## W366 Tumut MEC – Planning Hub RFI Response

**Date:** 16 April 2025

**Re: Acoustic Report – Reply to THE PLANNINGHUB Request for Additional Information – DA2025/0026 –Development Application (DA) at Russell Street, Tumut.**

**Figure 2. Layout Showing the Location of the Proposed Mechanical Plant to the Northwest of the Site. Source: The Facility Design Group.**

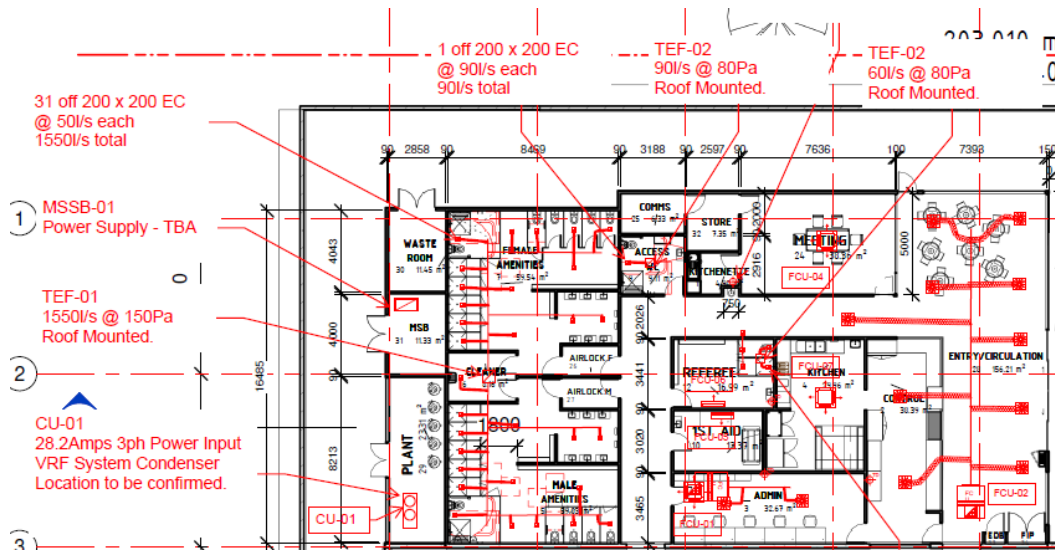
The CU-01, **Daikin REYQ22BYM09** heat recovery unit is proposed to be mounted in the plant room as shown in Figure 2 above. This has a sound power level of 85 dBA. The plant room is approximately 30 metres from the nearest residential boundaries. Hence, without attenuation the sound pressure level would be 48 dBA (from  $48 = 85 - 20 \log_{10} 30 - 8$ ). This exceeds the daytime noise goal by 4 dB and the evening/nighttime noise goal 13 dB. The unit is situated within the plant room but will require ventilation. Hence, mitigation is recommended. See section 7 below.

- The mechanical plant should not be used at nighttime (i.e., between 10:00 pm and 7:00 am on any day;
- A detailed design with the input from an acoustical consultant is recommended for the CU-01, Daikin REYQ22BYM09 heat recovery unit. The required noise reduction can be achieved with careful design involving the use of acoustic louvers and acoustic absorbent lined ducted discharge for the exhaust air;
- A rooftop acoustic barrier is recommended for each of the two closest basketball rooftop mounted coolers to the southeast and the two to the northwest. These two acoustic barriers should be at least 1 metre larger than the coolers, have enough mass to reflect a significant amount of sound and has no holes or gaps (including at the base);

**Figure 3. Plan Showing the Location of the Proposed Basketball Roof Top Mechanical Plant to the Nearest Residential Boundaries. Source: The Facility Design Group.**

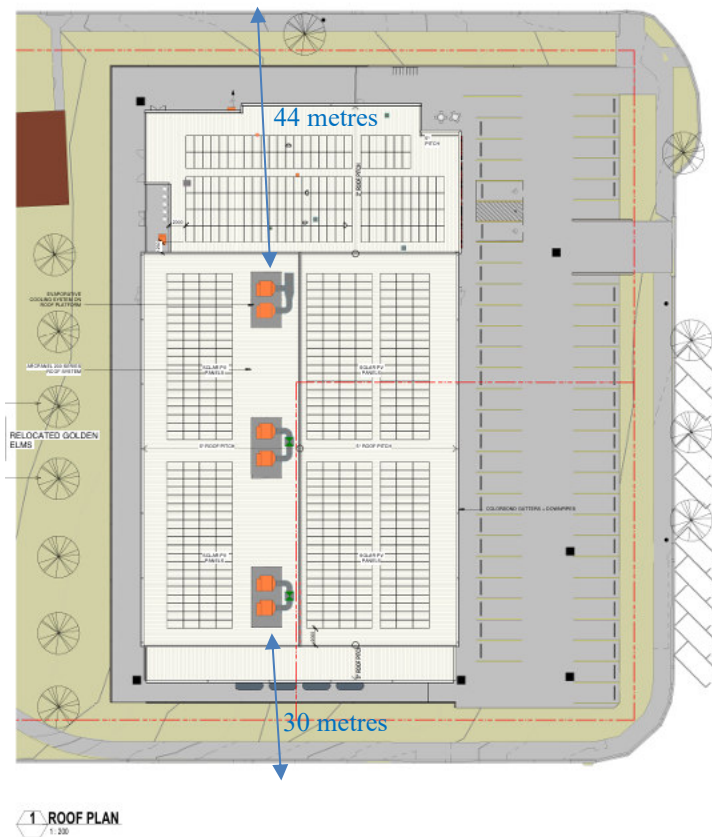
Mechanical Plant located to the Southeast consists of eight rooftop mounted coolers. These coolers are proposed in pairs at three different distances from nearest residential boundaries as shown in Figure 3 above. These are given as 48 dBA each which equates to 51 dBA for two. To the southeast these are approximately 30, 50 and 70 metres. To the north these are approximately 40, 65 and 85 metres.

To the southeast the only relevant mechanical plant noise will be the two closest rooftop mounted coolers which are predicted to exceed the evening time noise goal by 3 dB. Hence, mitigation will be required See section 7 below.

- It is recommended that the Fantech GUA454V fan is fitted with an Fantech (or equivalent) electronic speed-controller to enable the fan speed to be reduced at evening times.
- The mechanical plant should be well maintained to ensure that fan balance and/or faulty bearings (or similar) do lead to long term increase in noise levels;
- Signs should be place on, or near to, the car park areas advising users to people to minimise noise when arriving at and/or leaving the centre;
- No amplified music or public address systems should be used accepting in emergency situations.
- A community relations program should be implemented as detailed below.

**Figure 3 – Tumut Town Centre Traffic & Parking Study Fitzroy Street Hourly Traffic Volumes**

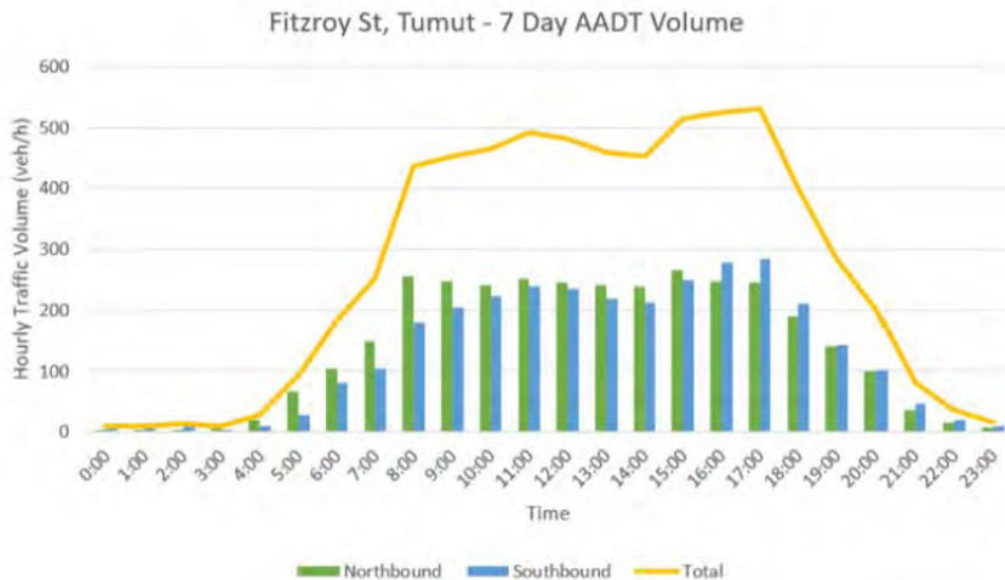
- *While the Traffic Impact Assessment (PT22075r01 – Tumut Multipurpose Facility TIA-Final\_A) provides some insights into potential traffic and parking impacts, it fails to adequately address the*

significant issues surrounding the 4:00 pm to 9:00 pm period, which is the time when the greatest traffic impacts are likely to occur.

The report provides analysis for the morning (7:00 am - 9:00 am) and afternoon (3:00 pm - 5:00 pm) periods, but there is a notable lack of focus on the evening period from 4:00 pm to 9:00 pm, when the greatest traffic impacts from the development are expected. During these hours, the following concerns arise:

Further and as clearly stated in the traffic impact assessment report prepared, a review of the Tumut Town Centre Traffic & Parking Study<sup>1</sup> Fitzroy Street Hourly Traffic Volumes showed that traffic flows near the site decrease markedly after 5pm and by 7pm are half the volume of 5pm recorded traffic. This is shown again below.

The above informed the appropriate times to conduct the intersection surveys to ensure periods of least road capacity were obtained. This approach ensures a robust and conservative traffic impact assessment of potential impacts.

Figure 4-16 Typical Weekday Parking Demand

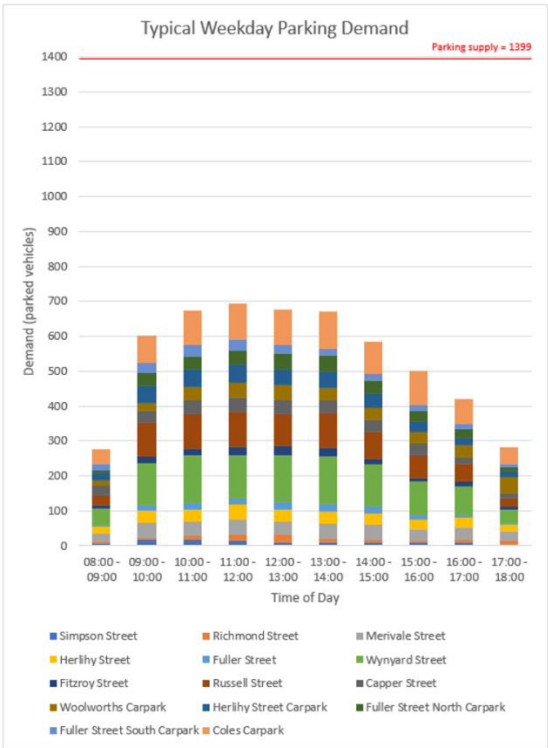
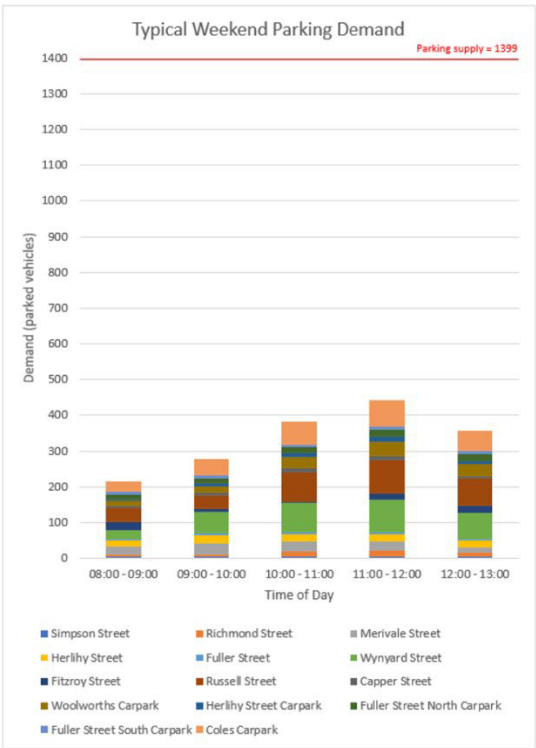
- **Inadequate Parking for Events:** While the study mentions 50 parking spaces for the development, it fails to account for the overflow parking that will spill onto local streets, particularly during evening events. This will result in significant strain on the existing parking particularly on streets where residents rely on on-street parking.

As cited in the TIA report, the Tumut Town Centre Traffic & Parking Study included a record of parking demands in Richmond Street across the frontage of the site as shown below in Figure 3-27 of the report.

The report found that total parking demands in the study are including Richmond Street where well below available capacity for a weekday and were lower on a weekend day as shown below in Figure 4-16 and Figure 4-17 of the report.

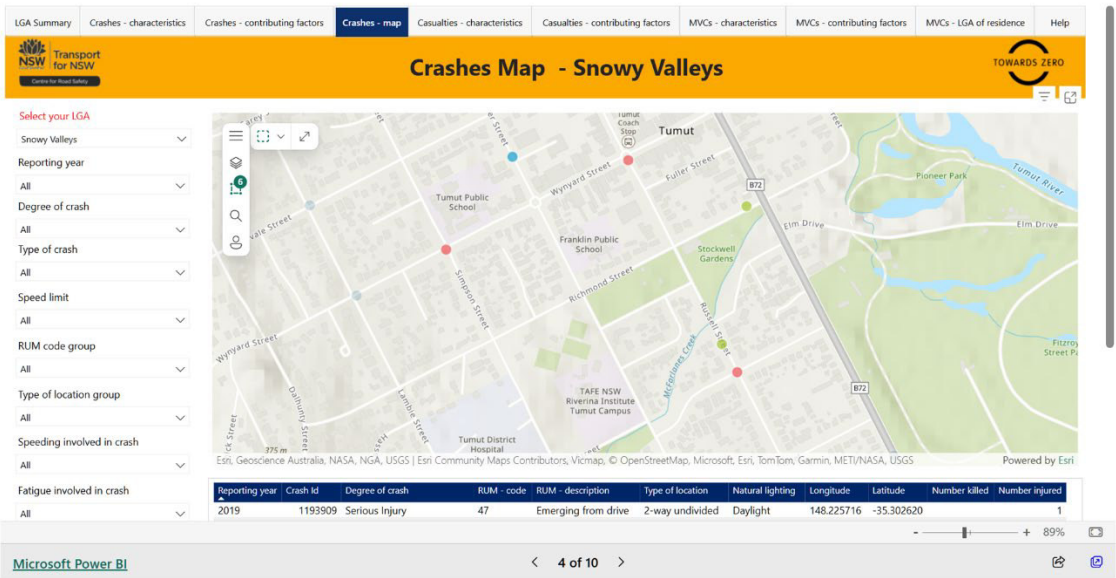
- **Safety Concerns at the Russell/Richmond Streets Intersection** *There has been no assessment of the impact of the existing give-way signs at the Russell/Richmond Streets intersection and how they will affect the flow of traffic into and out of the proposed facility. This is a major concern, as these intersections already experience congestion and delays during peak periods. The addition of traffic from the development will likely exacerbate these issues, causing further strain on the local road network.*

The above statement is contested.

The TIA report examines both the existing and future intersection operating conditions under the current Give Way priority arrangements for the intersection of Richmond Street and Russell Street. The modelling of both existing and future conditions confirm that the intersection would continue to operate at Level of Service A with little delay.
